DESIGN REVIEW - RECOMMENDATION PROPOSAL

300 W Republican Street, Seattle, WA 98119

NEW MULTIFAMILY BUILDING | KOZ DEVELOPMENT

SDCI # 3036974-EG
West Design Review Board Meeting Packet
for August 18, 2021

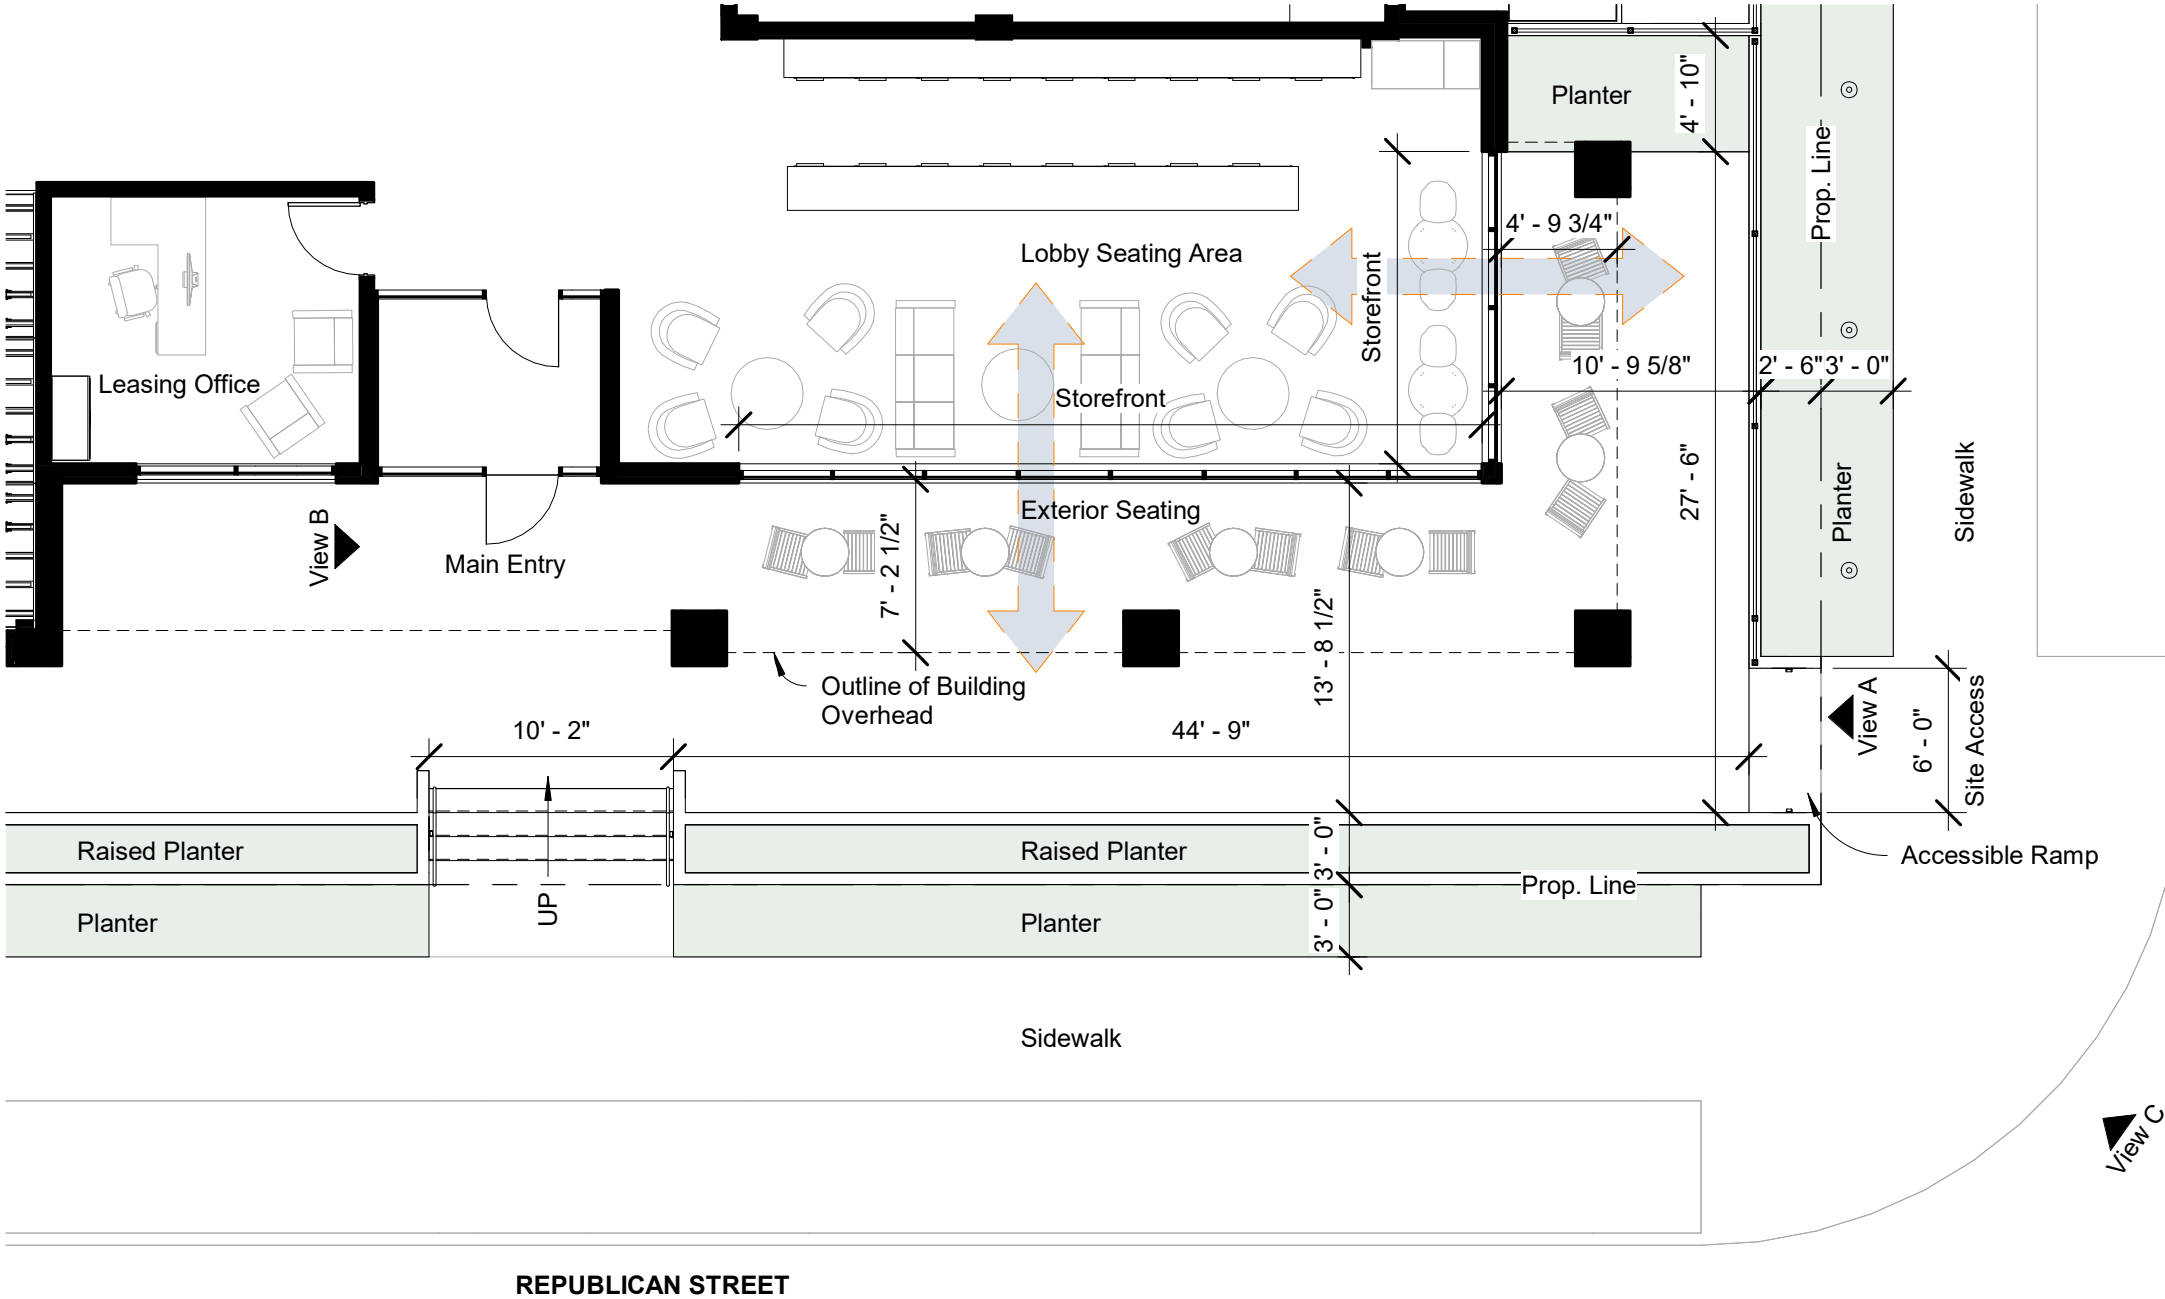
a.) The Board supported the concept of the corner courtyard, but noted there was not much information in the EDG packet to comment on. The Board specifically prioritized Uptown Design Guidelines CS2-3-a, Address the Corner; CS2-3-c, Special Features; and PL1-1, Enhancing Open Spaces, to be applied as the design evolves. (CS2-3-a, CS2-3-c, PL1-1, DC3)

Response
The placement of the exterior porch on the corner of 3rd and Republican at the southeast corner of the site seeks to create an architectural gesture that becomes a focal point for the project and addresses the corner location. The exterior patio is accentuated with a unique recessed portion of the façade at the corner and the use of an accent cladding material. The recessed façade creates a covered area for seating and also makes a larger patio area. The use of the open space at the main level serves to promote activity and to "activate" the corner at the pedestrian level. The interior common space and lobby are located adjacent to the exterior open space to further promote additional engagement with the public ROW. A raised planter and landscape bed provide both privacy and transparency from the adjacent sidewalk along republican and a privacy fence and landscape planter provide a similar effect along 3rd avenue.

2 Partial 3rd Ave Section
3/16" = 1'-0"

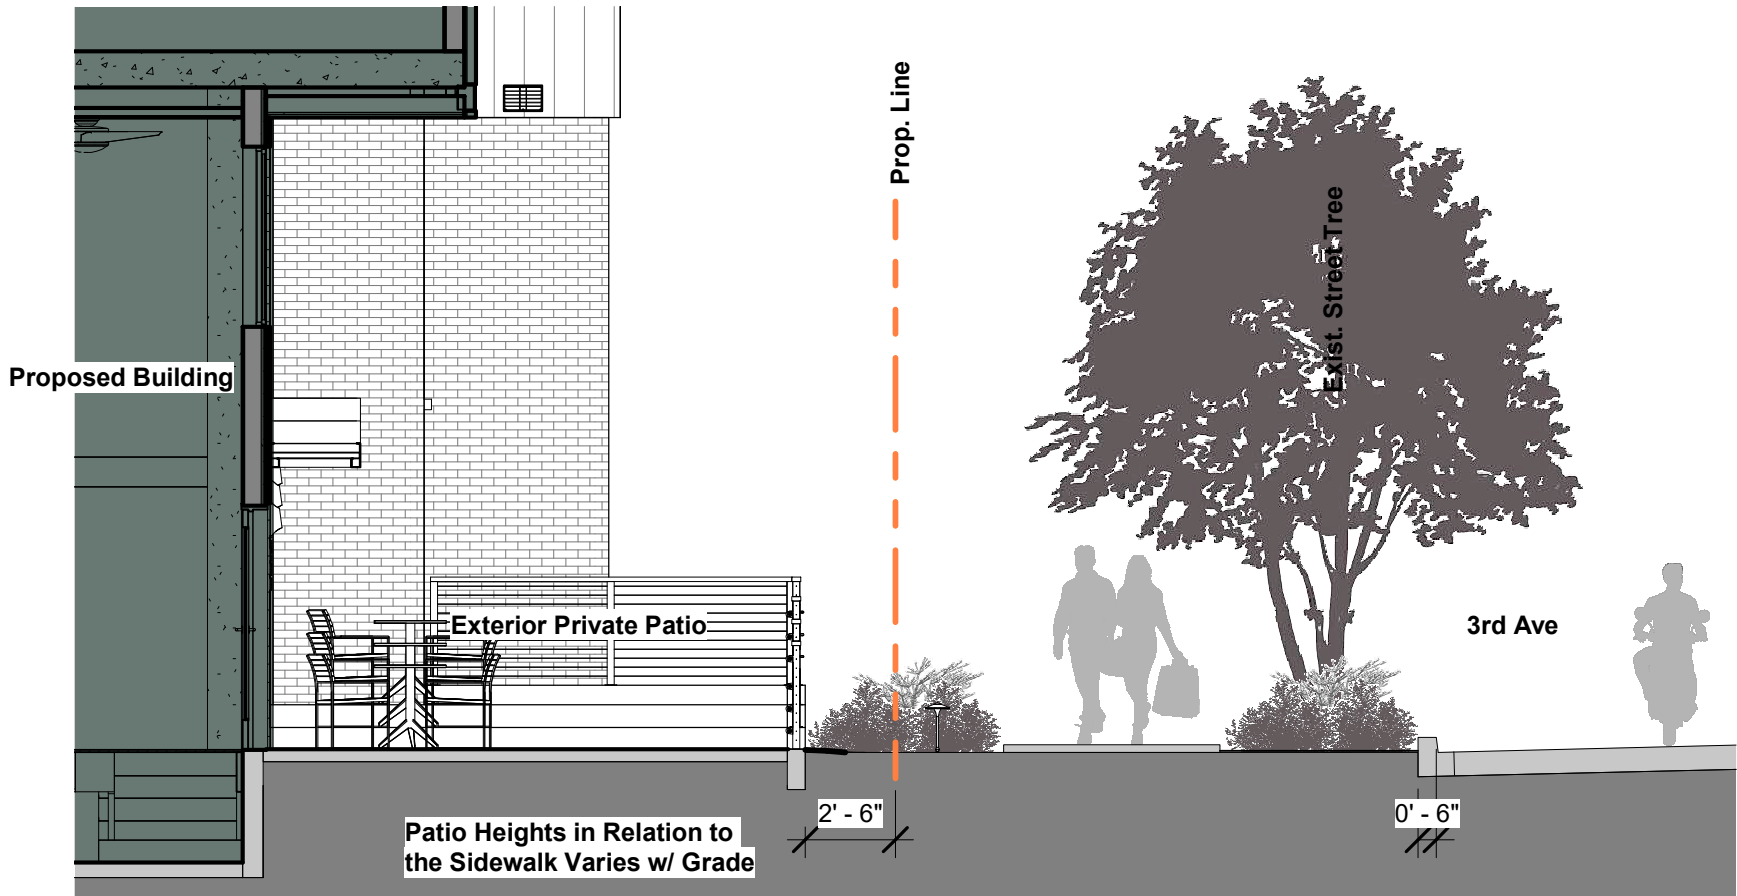
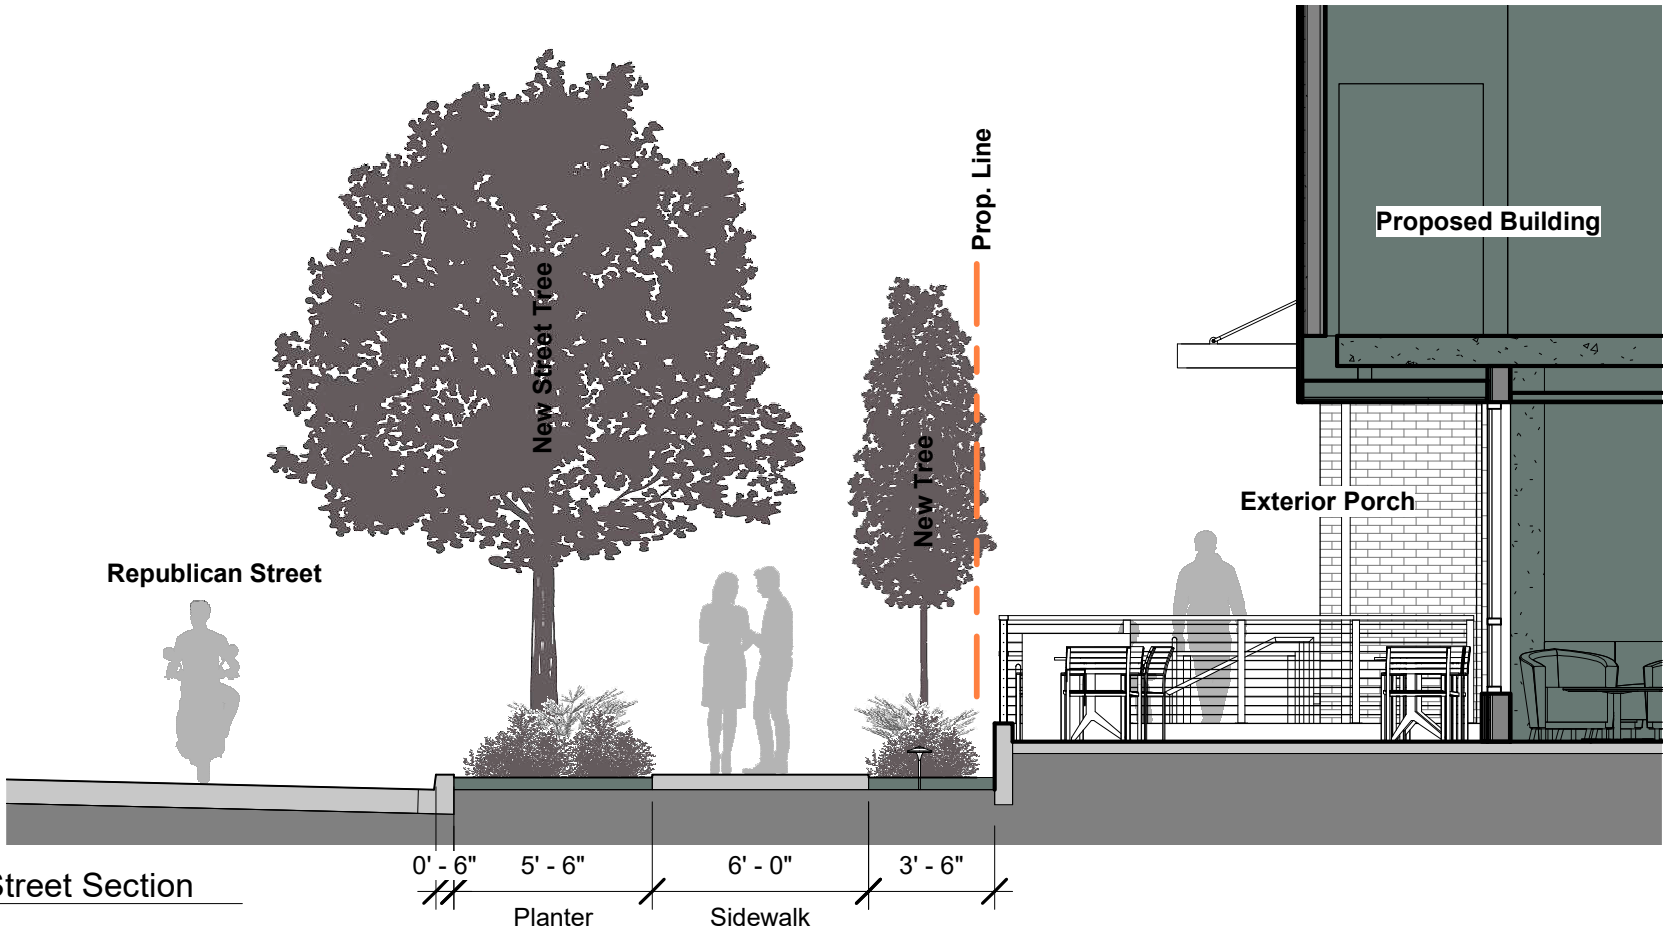
b.) In response to SDOT and public comment, the Board specifically prioritized Uptown Design Guideline PL1-3-c, Pedestrian Uses, which states, “All of Uptown should be considered a “walking district.” New development should strive to ... create an attractive and vibrant pedestrian environment. Consider widening narrow sidewalks...” (PL1-B, PL1-3-c)

Response
The current design proposes a 6’ wide sidewalk along both street frontages with a 5’-6” street tree planting buffer on the street side of the sidewalk and a 3’-0” planter between the walk and the property line. Additional planting and open space are proposed between the property line and the building to enhance the pedestrian experience. The overall intent of the pedestrian level design is to provide an attractive, lively, and vibrant landscaped sidewalk experience along the sidewalk. Exposed concrete walls are proposed to be textured for visual interest and other landscape features such as lighting and boulders are proposed within the planting beds adjacent to the sidewalk.

1 Site Lighting Plan - Current Proposal
1/16" = 1'-0"

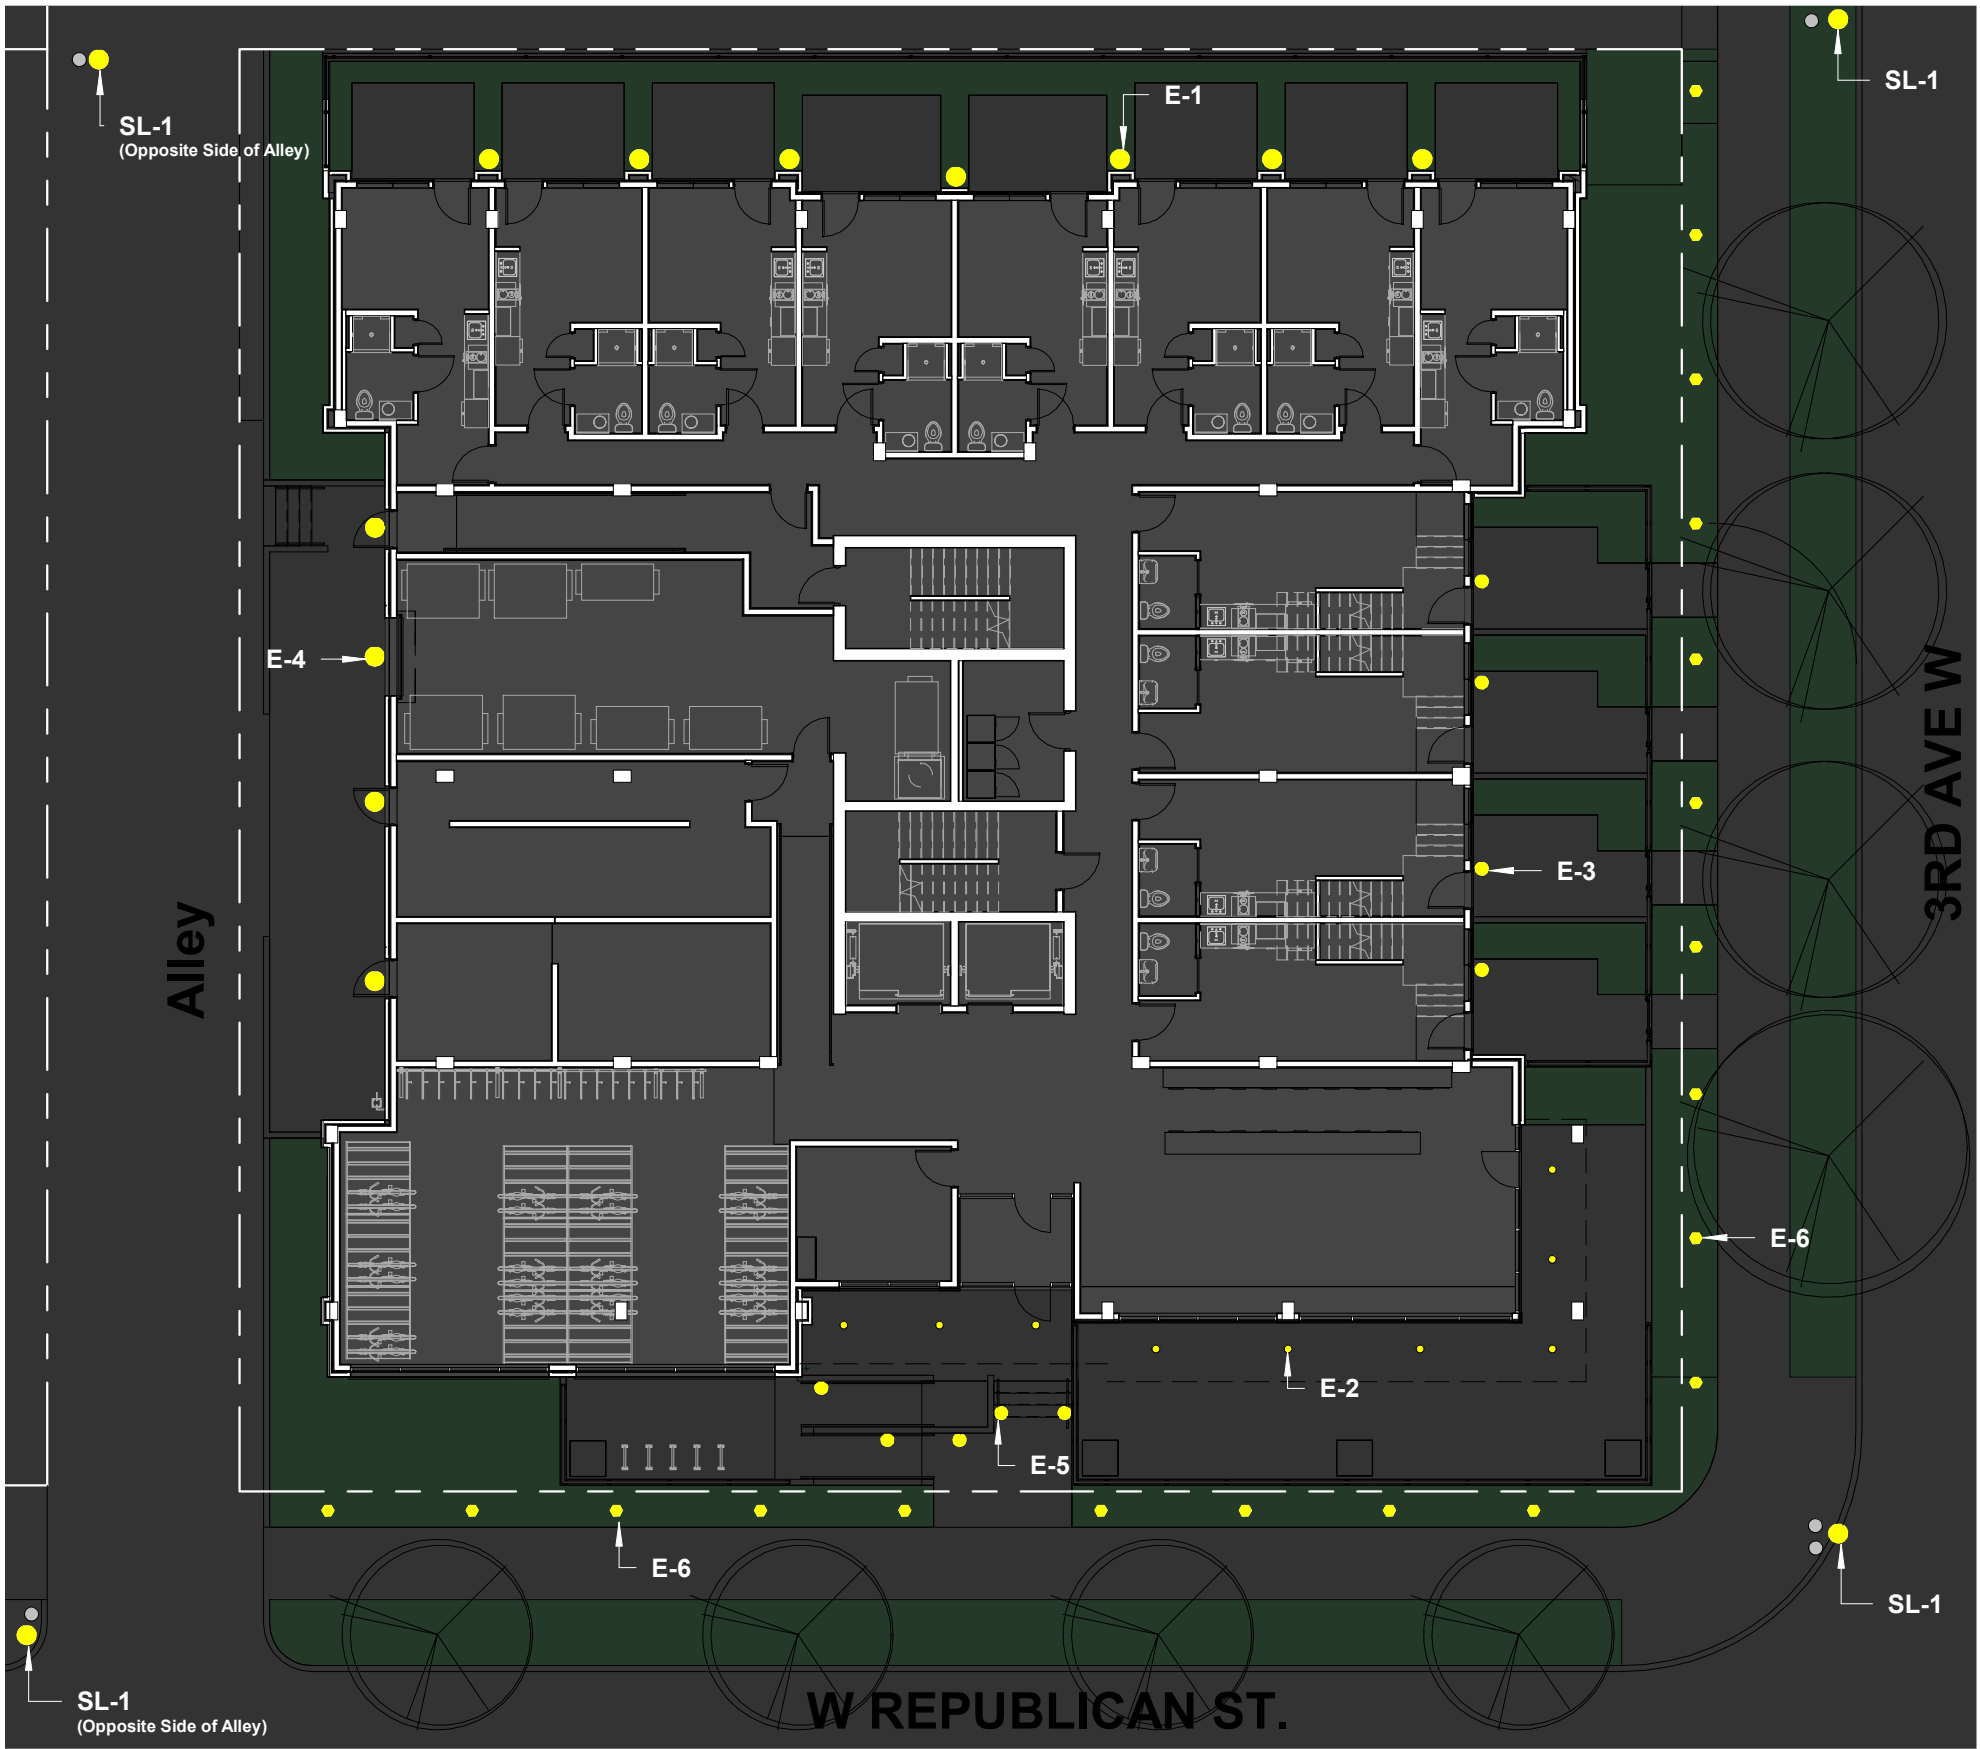
d.) The Board specifically prioritized Design Guidelines DC4-B, Signage, and DC4-C, Lighting, and stated the lighting plan should avoid “up lighting”. (DC4-B, DC4-C)

Attention has been given to the pedestrian level lighting adjacent to the sidewalks within the landscaping, building mounted lighting, and illumination for the building signage. The previously proposed landscape uplighting has been deleted. For additional details on lighting design, type, and locations refer to the lighting site plan and lighting elevations within this packet. For signage location, lighting, and details refer to the signage concept plan within this packet.

A rhythm of up/down wall mounted building lighting is proposed along the base of the building. At the lower level residential units the fixture type would change type to help create an individual expression and residential feel. The concrete landscape # 2 planters along 3rd Ave and Republican Street shall have appropriate pedestrian-scaled lighting within the planters. All lighting is intended to provide both security and visual interest to the building.
